To	Moremac Pty Ltd, C/- KLM Spatial	From	Nina Barich
Copy		Reference	2403
Date	8 October 2024	Pages (including this page)	13
Subject	350 Narre Warren Cranbourne Road, Cranbourne East - Without Prejudice

The review has identified the following key changes to the Melbourne Water Croskell Drainage Strategy:

Figure 4.1 – Revised RORB Subareas Existing Conditions

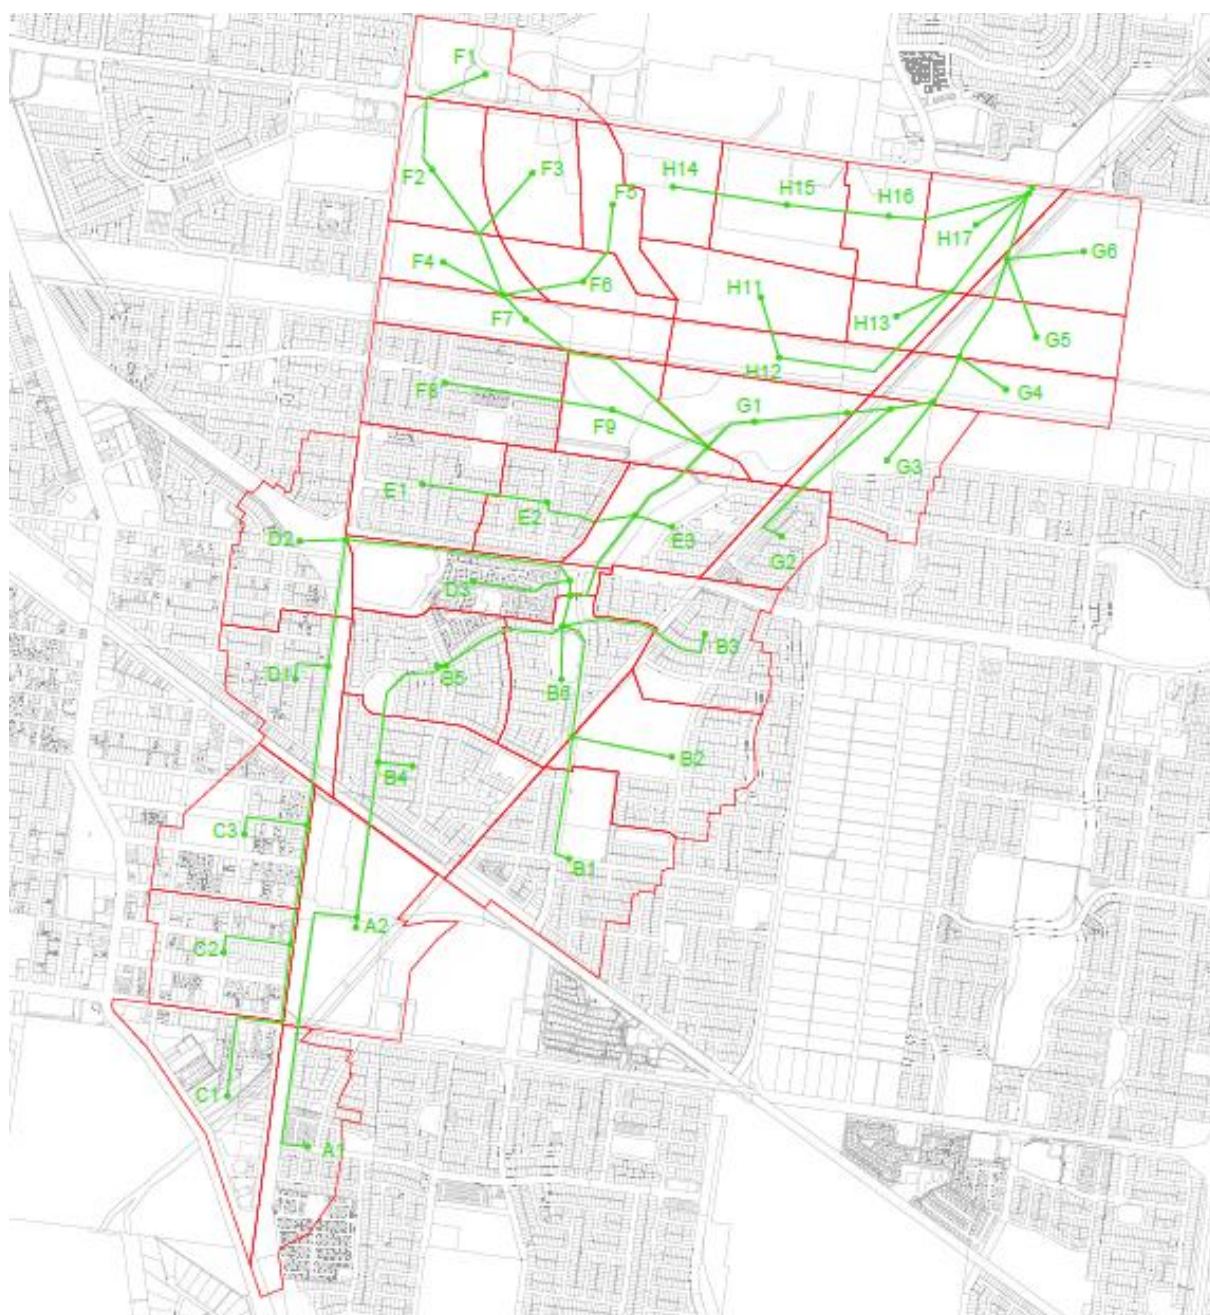
Incitus has created an extract of the Melbourne Water RORB model encompassing the western catchment of the Croskell PSP Thompsons Road, with a revised subarea breakdown for the western catchment in the Croskell PSP to ensure there is a minimum of 5 subareas upstream of hydrograph print locations and with subareas more evenly distributed.

The Incitus existing conditions model has adopted type 1 reaches where there is no development or any existing cut drain, and type 2 reaches for existing urbanised areas.

The existing retarding basins 0619-16 (the Hunt Club) and 0619-45 (at Linsell Boulevard) have been included as per the Melbourne Water model, however it should be noted that 0619-16 has been moved to located it where the catchment is connecting (downstream of Incitus subarea B4, not where the Melbourne Water model has it at subarea C, as this subarea and upstream catchment bypasses around the 0619-16 asset).

The same modelling parameters were applied as those adopted in the Melbourne Water model; however, the kc value was altered to reflect the revised Dav of the model excerpt and a kc of 5.65 for existing conditions and a kc value of 5.57 for developed conditions is used. **Figure 4.1** illustrates the revised existing RORB subareas for the western catchment of the Croskell PSP, and **Figure 4.2** illustrates the revised developed RORB subareas for the western catchment of the Croskell PSP.

Figure 4.2 – Revised RORB Subareas Developed Conditions

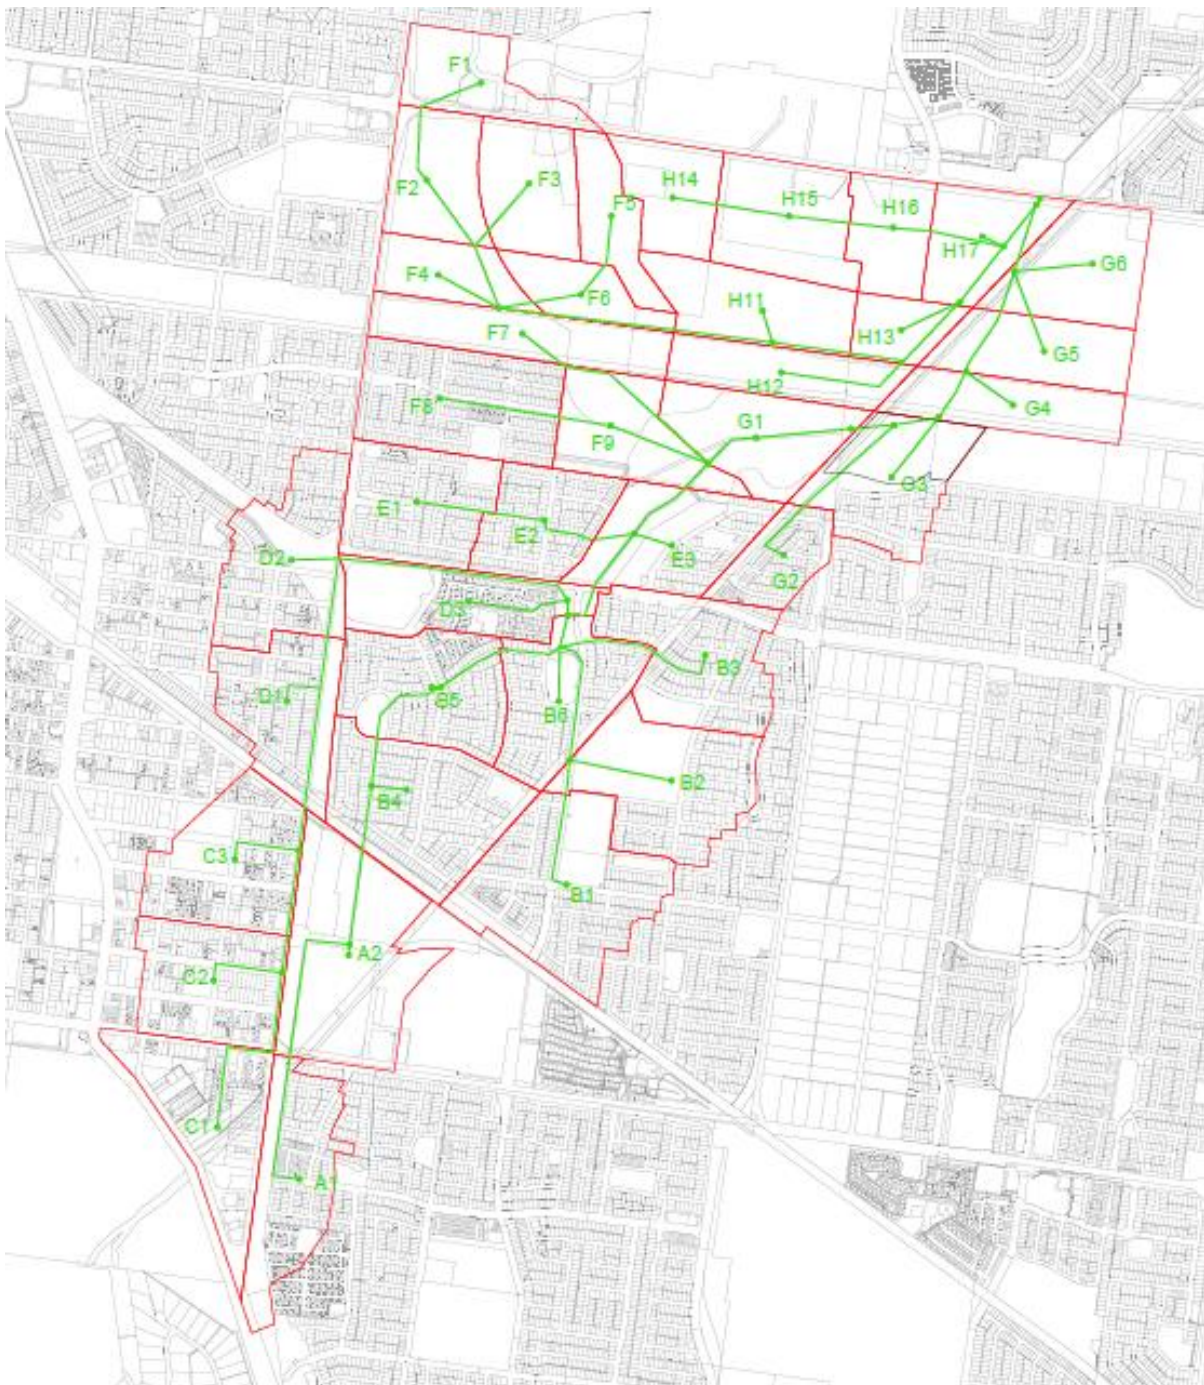
The developed model has incorporated the proposed pipeline to connect the north-west catchment east along the northern boundary of the existing easement so that the existing volume is not exceeded. However, unlike the Melbourne Water model, the Incitus design RORB model has also diverted the runoff from the existing subarea F4 to the east. This decision was made as the additional runoff generated from this subarea increases the peak 1% AEP design flow with climate change at the pipe diversion location by only 2 m³/s, which can be incorporated into the nominated pipes if they are marginally steepened. This option also removes the requirement to construct a crossing over the VDP.

The Incitus model is based on conveying the full 1% AEP design flow including climate change in the diversion pipe. This is because the pipeline needs to be conveyed through a minor hill, and the gap flows nominated to be conveyed in the road reserve by Melbourne Water's model cannot be done without a significant cut and additional land-take for the road reserve adjacent to the easement.

Figure 4.3 – Incitus Proposed Drainage Reserves, Excluding Ti Tree Creek Waterway Reserve and Without Buffers, for the Croskell PSP Western Catchment

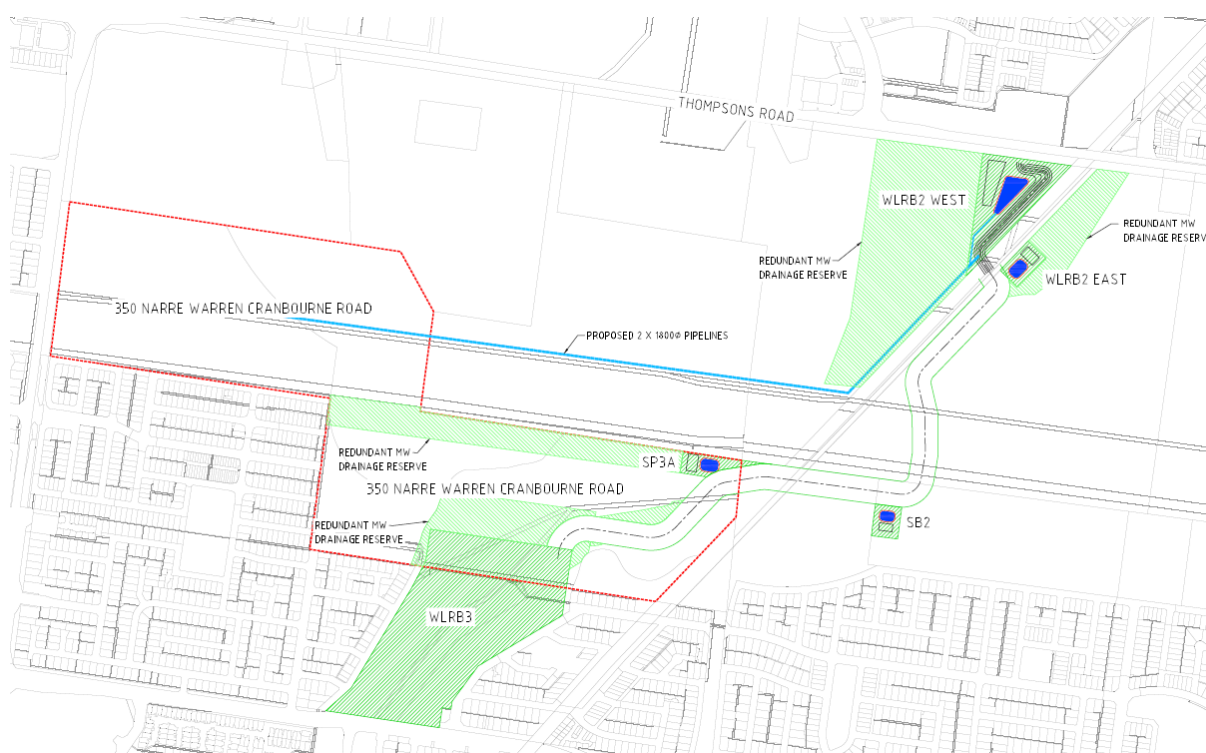
As Melbourne Water's proposed WLRB3 provides sufficient nutrient reduction for the runoff generated from the Croskell PSP, it is not proposed to incorporate any additional treatment for nutrient reduction in the western catchment. The drainage reserve sizes have accounted for safe batters to the normal water level (NWL) of the sediment ponds, the dry-out area required, a path surrounding the perimeter of the sediment ponds and appropriate offset to development. The drainage reserve for WLRB2 West also includes retardation, adopting a bypass for Ti Tree Creek to convey the 10% AEP design flow.

Figure 2.3 illustrates the proposed drainage reserves for the Croskell PSP, noting that the Ti Tree Creek waterway reserve has not been realigned in this Figure with the exception of through WLRB2 West.
